UNITED STATES PATENT AND TRADEMARK OFFICE

10/595,149

Office Action Summary	Application No. 10/595,149	Applicant(s) NEISE, RALF	
	Examiner ANTHONY L. BACON	Art Unit 3747

DETAILED ACTION

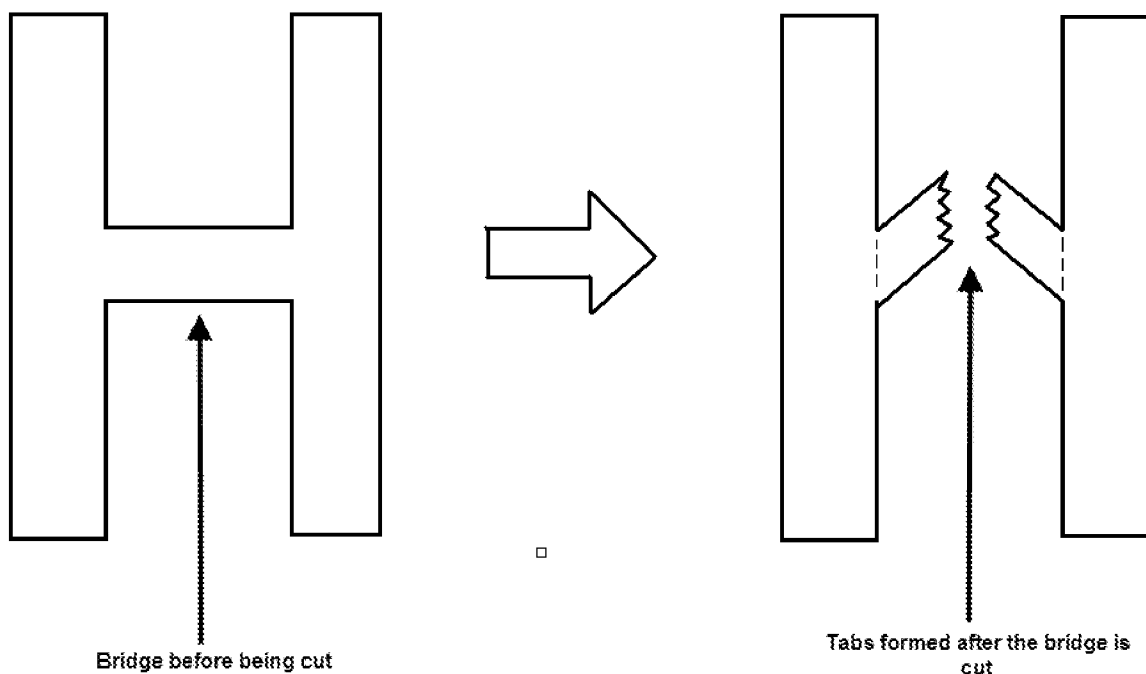
14. In Re claim 9, Zdanys, Jr. et al ('407) , with reference to figure 7, discloses tabs for crimping to promote positive engagement by passing said tabs through a recess in a substrate and also to separate the bridges in order to prevent a short. The examiner notes that by cutting the bridges down the center, the bridge would necessarily deform during this process, during which a tabular feature would then be formed which could be used in a known manner, such as previously mentioned, in which case the bridge would then be able to also provide positive engagement to the housing. See also the figure below.
